PROJECT: CE System 80+

SUBJECT: PUBLIC MEETING OF DECEMBER 14, 1993, REGARDING STRUCTURAL AND GEOSCIENCES ISSUES FOR THE ABB-CE SYSTEM 80+ STANDARD PLANT DESIGN

ENCLOSURE 2  
CE SYSTEM 80+ STRUCTURAL/GEOTECHNICAL ISSUES UPDATE  
AGENDA FOR MEETING ON 11/10/93

METHODOLOGY FOR COMPUTING SLIDING  
UNDER EARTHQUAKE LOADS

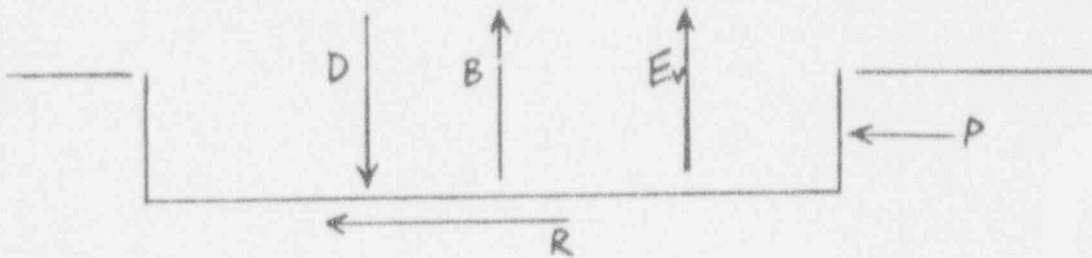
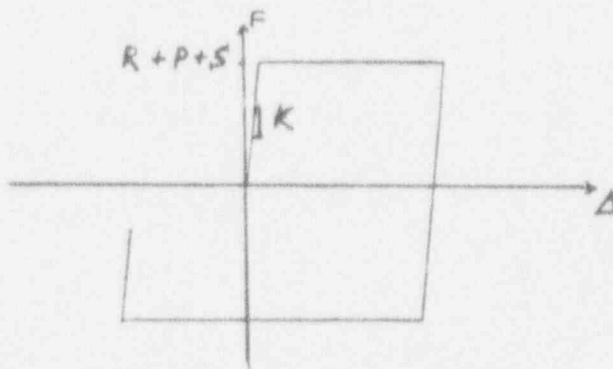
- Status: Confirmatory. DESI will revise the calculations to address thermal loads. See CESSAR Amendment U, Appendix 3.8B, Section 5.10.2 and 5.10.4.
- (6) The use of a friction coefficient of 0.7 (based on  $\phi = 35^\circ$ ) is not acceptable. As such, the sliding evaluation must be revised.

- Status: Technically Resolved. DESI will revise the calculations to address issue of coefficient of friction.
- (7) All calculations supporting the CESSAR must satisfy applicable Quality Assurance Requirements and conform to good engineering practices. References to input documents should be clearly noted and superseded/invalid segments of the calculations should be clearly marked so that a reviewer or user of the calculation can understand the calculation process in absence of the originator of the calculations.
